RE: **Lot 12 Block 3 Unit 22 SAD 228**
6509 Camino Del Oeste NW
Volcano Cliffs Subdivision
Grading and Drainage Plan
Engineers Stamp Date 12/20/2022 (D10D003U14)
Pad Certificate Date: 1/12/2023
CO Certification Date: 7/28/2023

RE: **Lot 14 Block 3 Unit 19 SAD 228**
6509 Camino Del Oeste NW
Volcano Cliffs Subdivision
Grading and Drainage Plan Date: 10/24/2022
Revised Grading and Drainage Plan Date: 12/20/2022
File Number (D10D003U14)

ENGINEER'S SEAL DAVID SOULE P.E. #14522	LOT 12 BLK 3 UN 19 VC 6509 CAMINO DEL OESTE GRADING AND DRAINAGE PLAN P.O. BOX 53924 ALBUQUERQUE, NM 87199 (505) 321-9099	DRAWN BY DEM
		DATE 12-14-22
		SHEET # C1
		JOB #

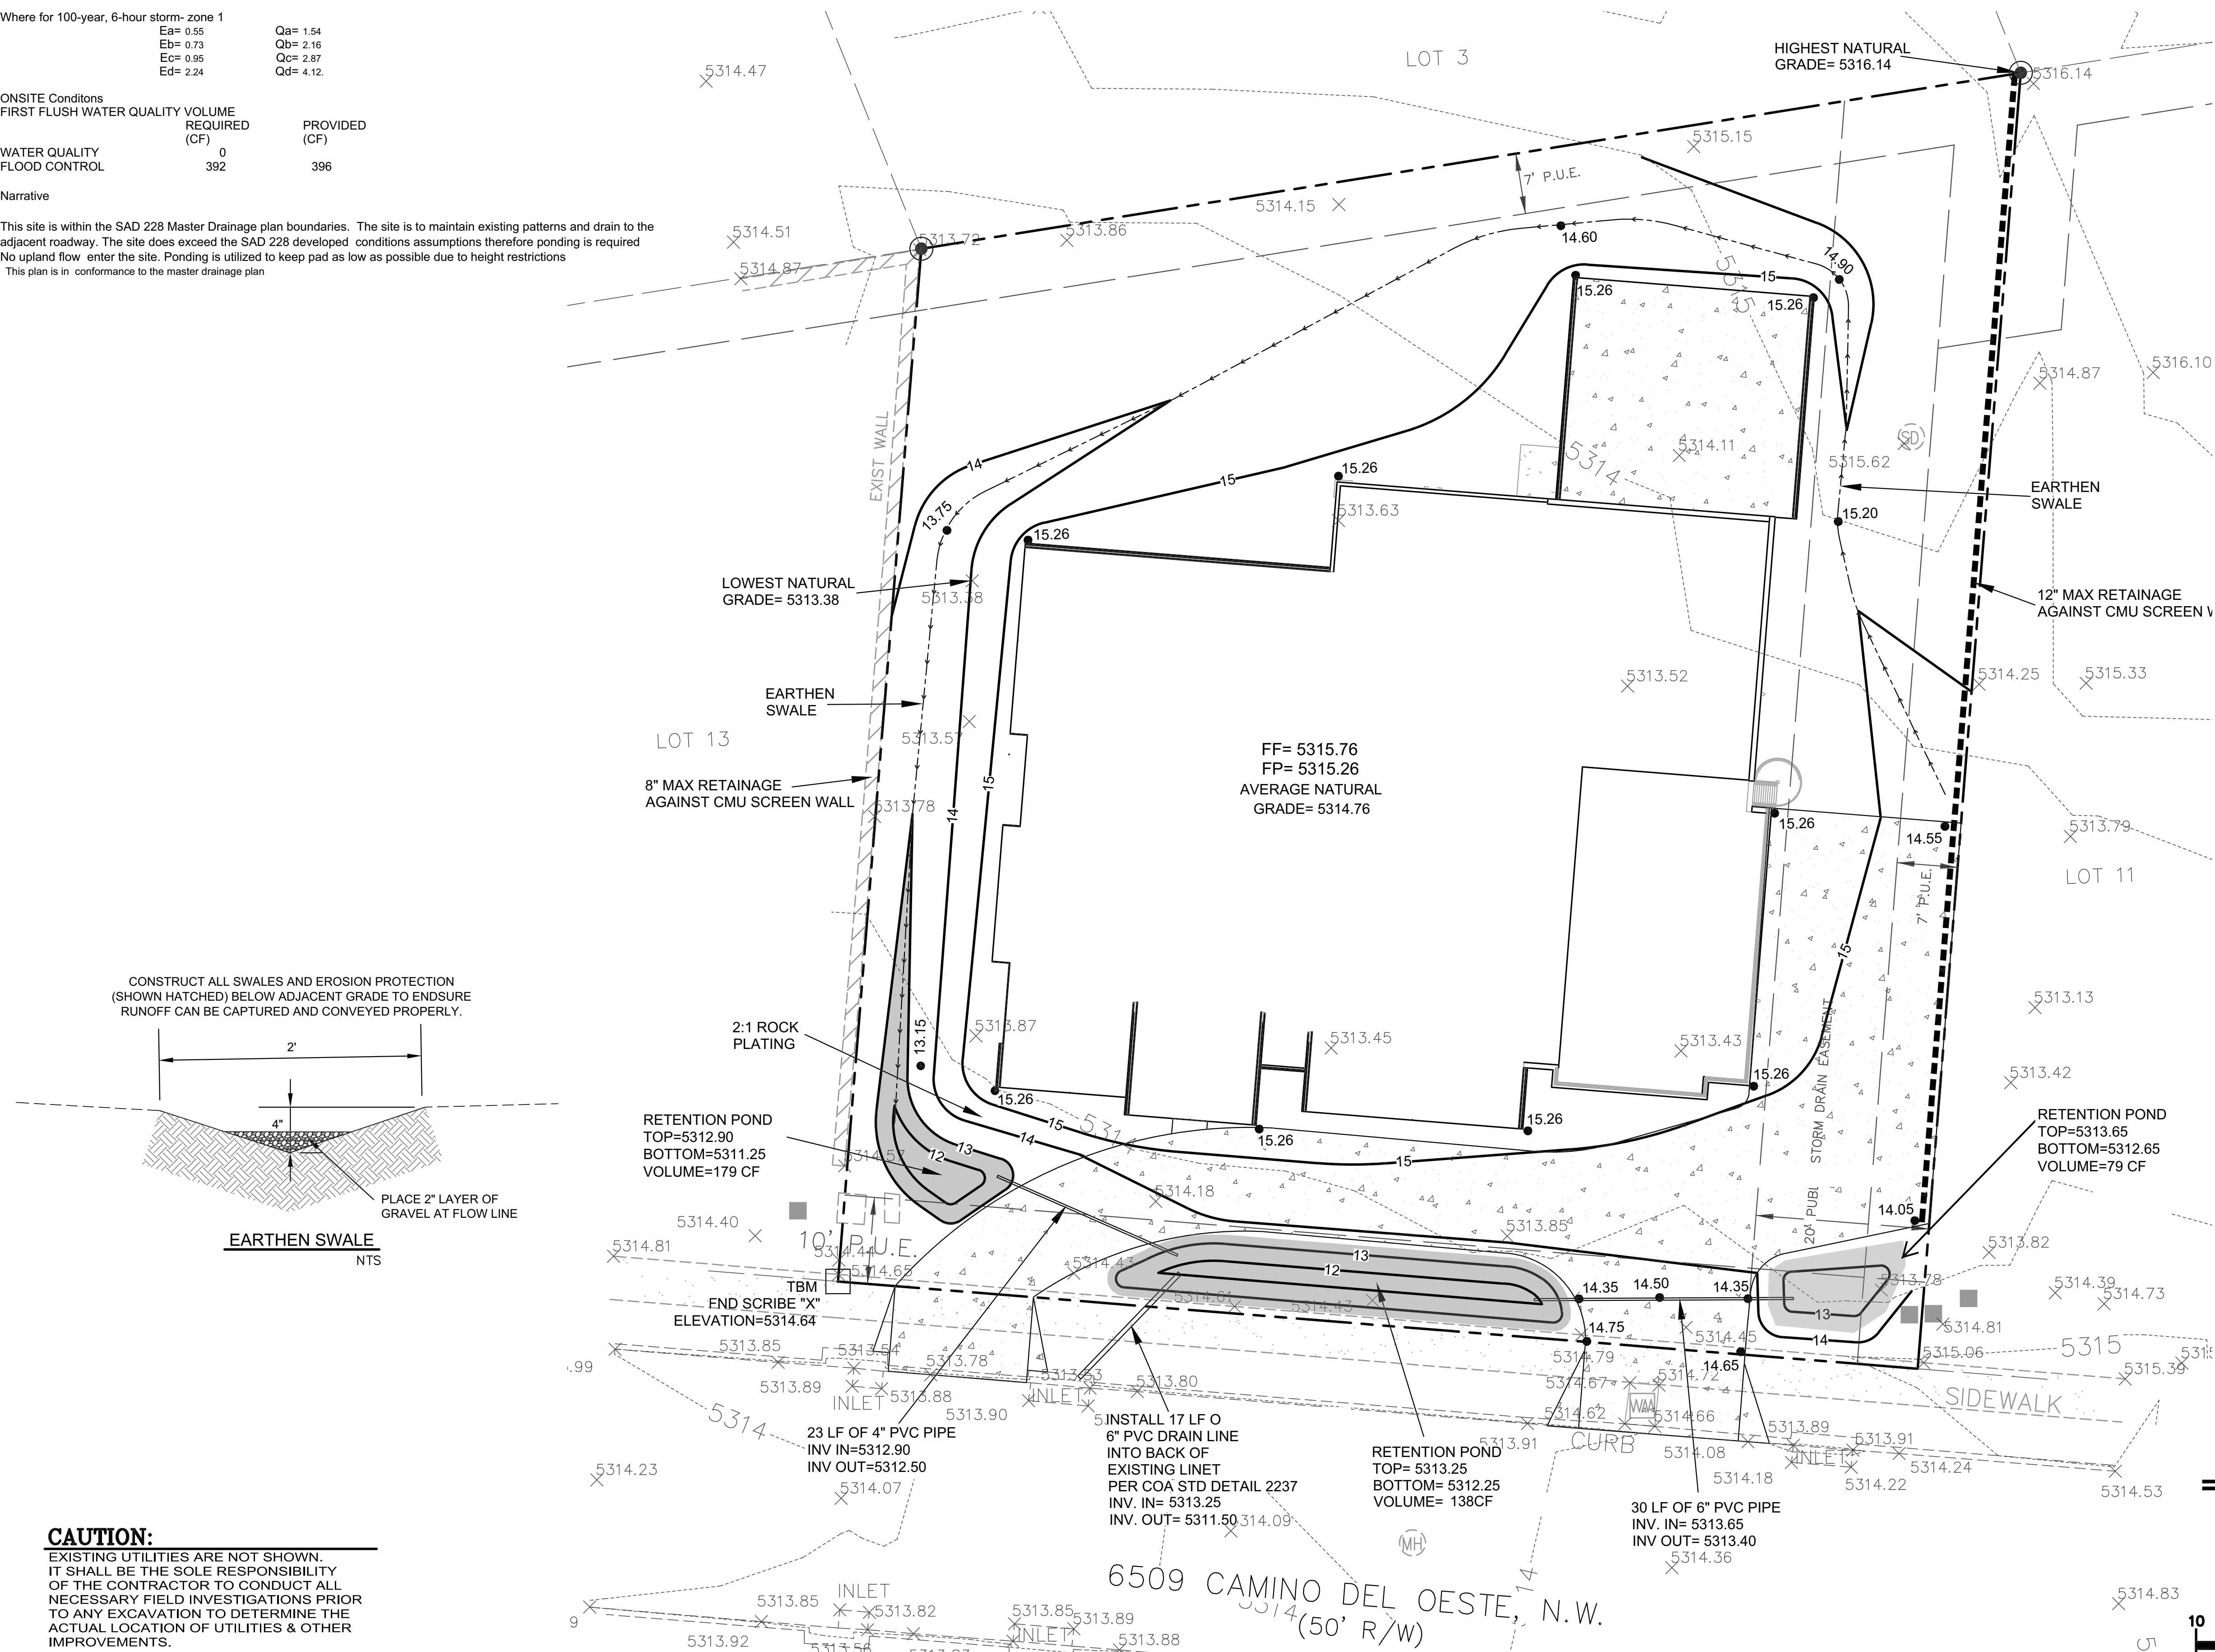
Based upon the information provided in your submittal received 12/20/2022, this plan is approved for Grading Permit and will now be the plan of record.

Prior to Building permit approval a Pad Certification will be required, provided by the Engineer or a registered Land Surveyor.

Advise the owner contractor not to use dirt as a ramp to climb the curb, use lumber or crusher fines for this purpose.

Reiterate to the Owner/Contractor that a separate permit for a garden/retaining wall must be obtained with the approved G&D plan and Pad Certification. Also, if a swimming pool is to be placed the grading and drainage plan will change and will need to be resubmitted.

Prior to Certificate of Occupancy release, Engineer Certification per the DPM checklist is required.
